Addendum No.: 4

Date Of Addendum: 9/11/2020

**Roof Top A/C and Roof Replacement
300 Corporate Place
Rocky Hill, CT
BI-2B-387**

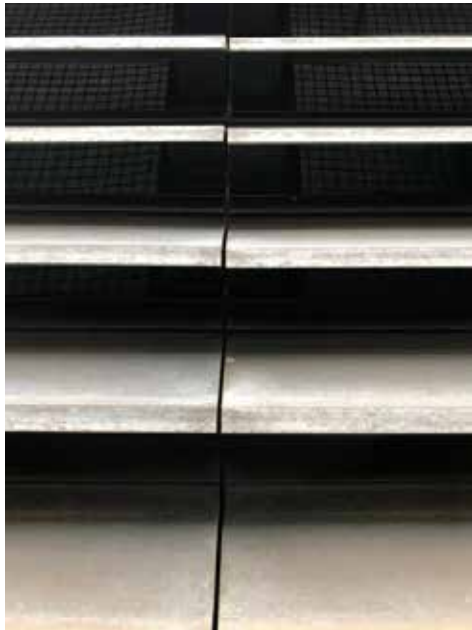
Q: More information is needed on the louver section that is to be removed for the 2-24" diameter temp ducts. We need to know how big the louver section to be removed is and how it is fastened together.

A: Refer to architectural detail M/A-302 for fastening method of louver to building. The overall louver is approximately 20'-0"L x 8'-0"H. The louver is split into two sections. See image below at louver section.
